Project:	2022-RFT-026 821131 – Solid Waste WTS Construction		
Addendum No.	06	No. of Pages:	5
Date:	2022-08-17	Doc. No.:	P7201-1591092266-188(1.0)

The purpose of this Addendum is to clarify and answer for bidder's question on tender 2022-RFT-026 issued for bid on July 12, 2022.

CITY OF IQALUIT WASTE TRANSFER STATION		PROJECT NO. 19-9543
MECHANICAL LAYOUT - HVAC		SHEET NO. WTS.M02

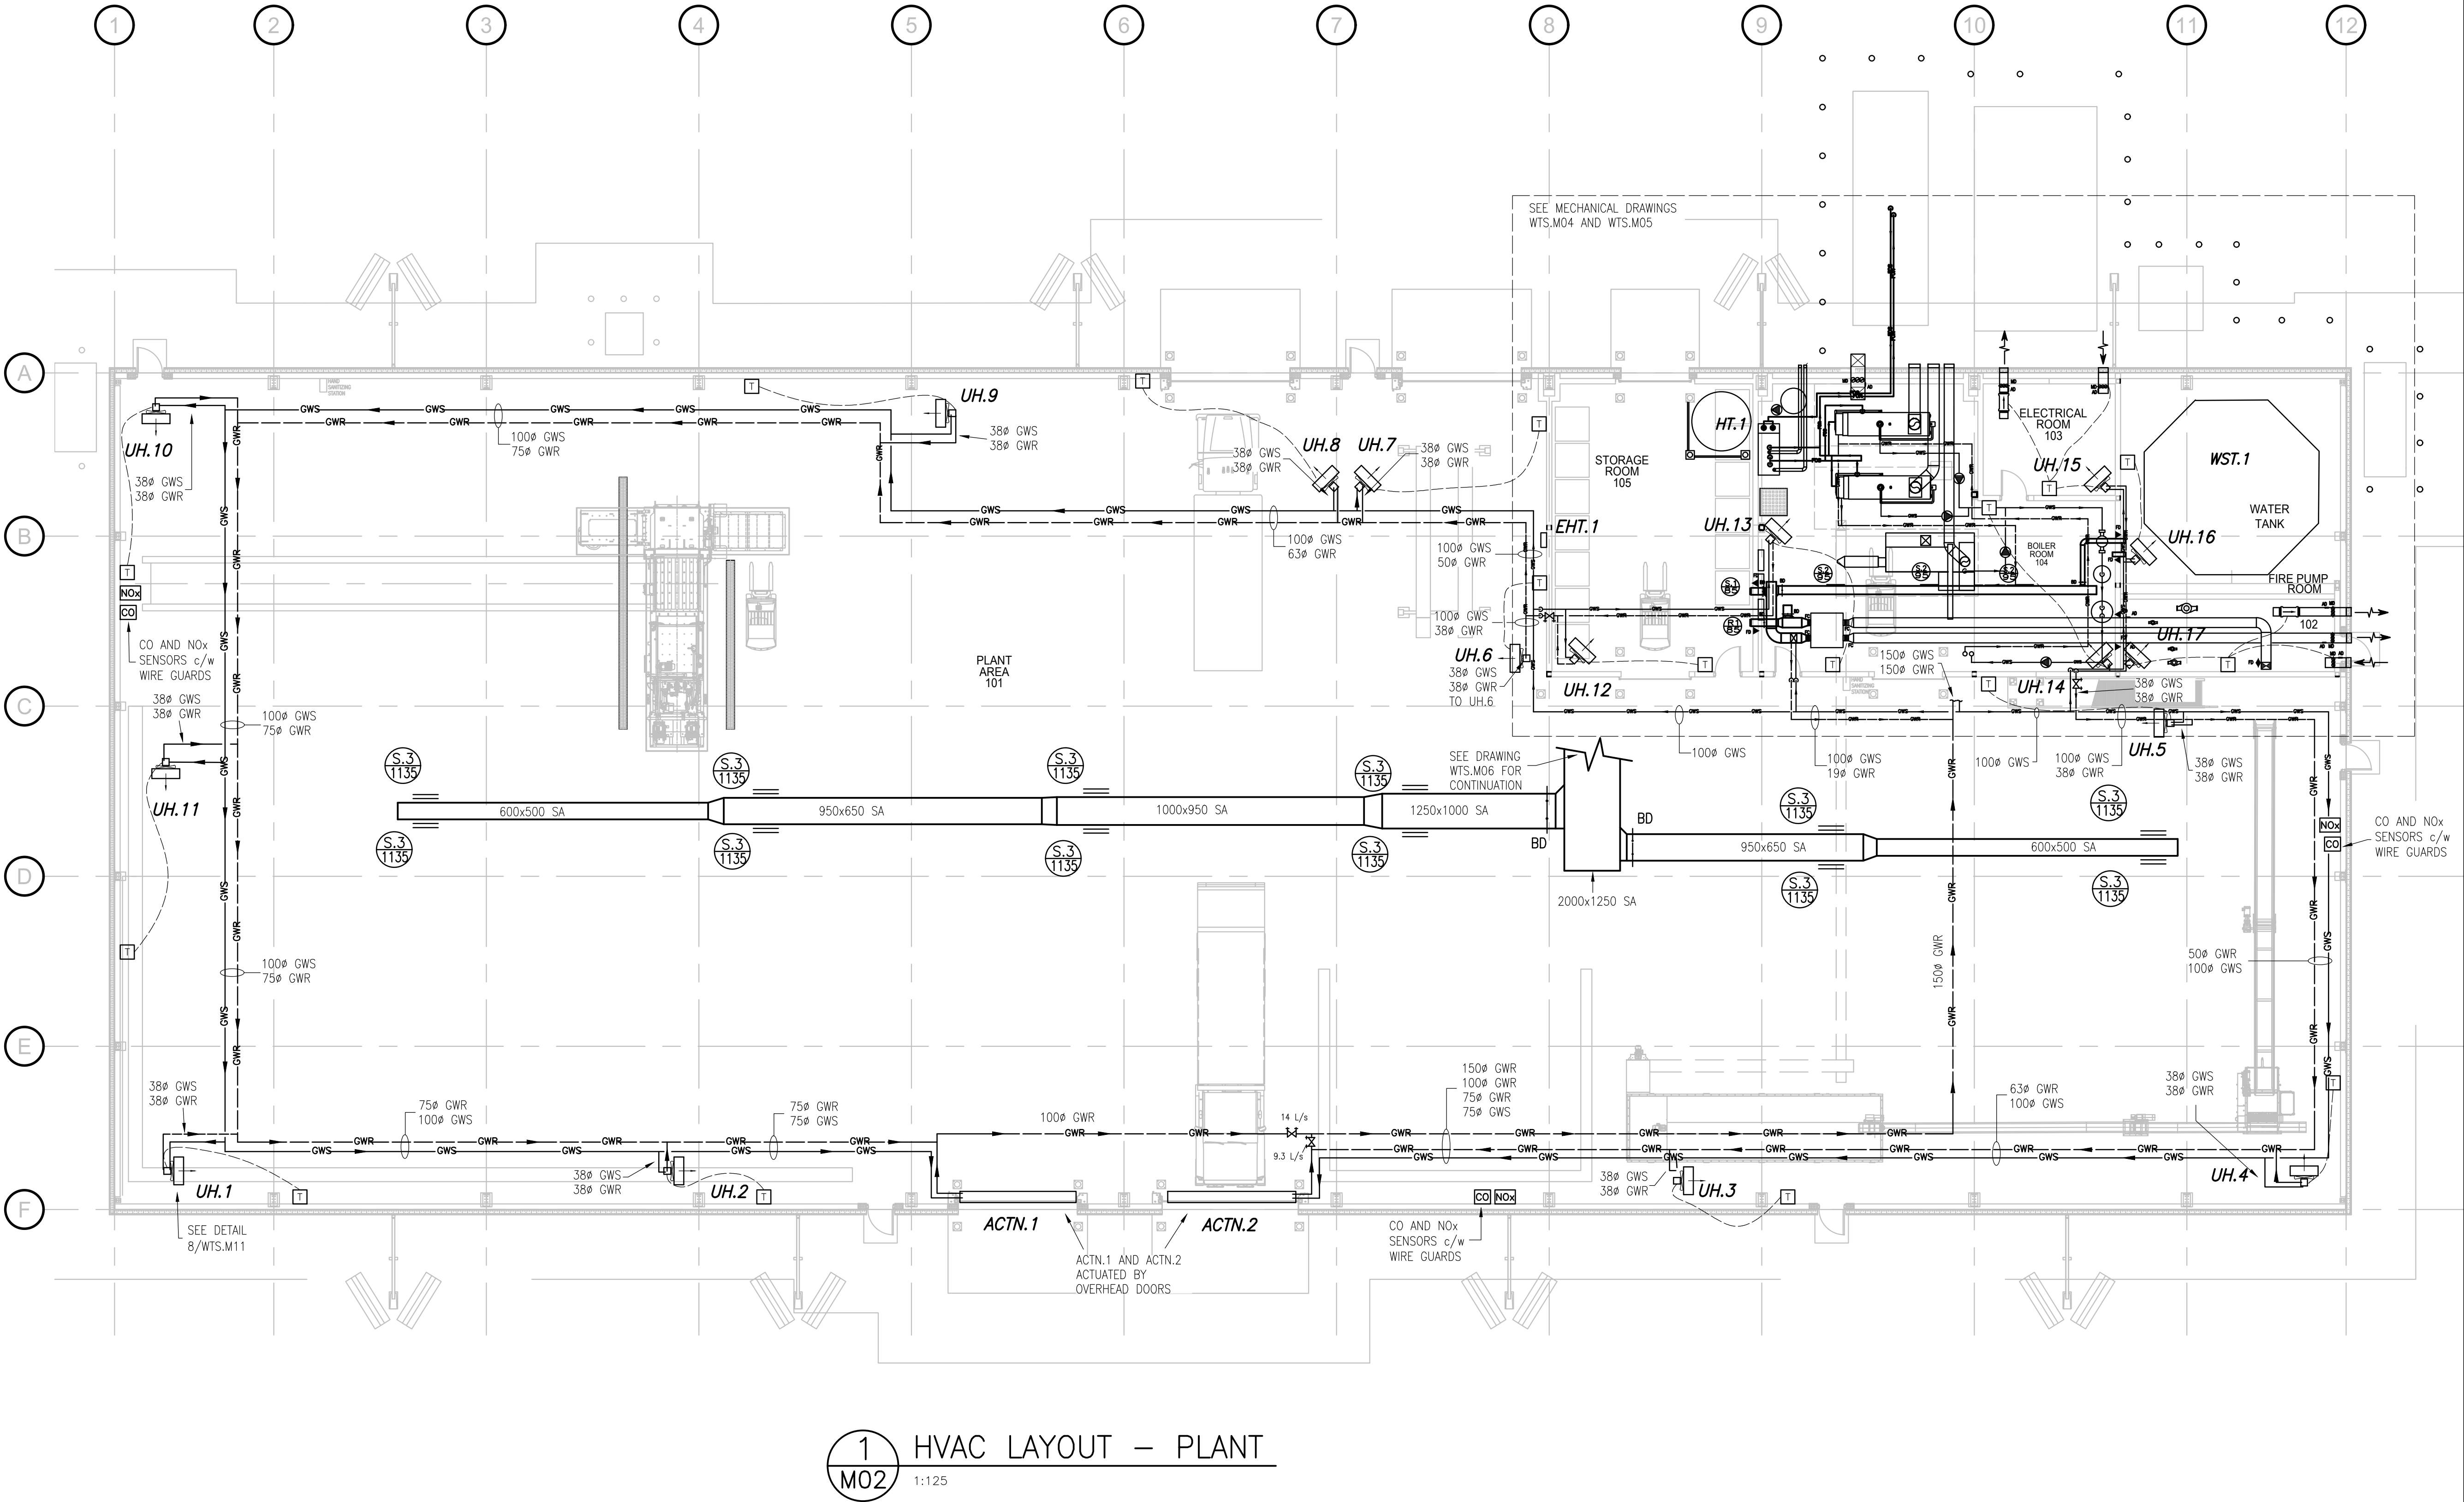
1. Replace existing drawing WTS.M02 rev 9 with attached rev 10 (enclosed).
2. Add NOx sensors c/w wire guards as shown.
3. Revise GWR piping as shown.
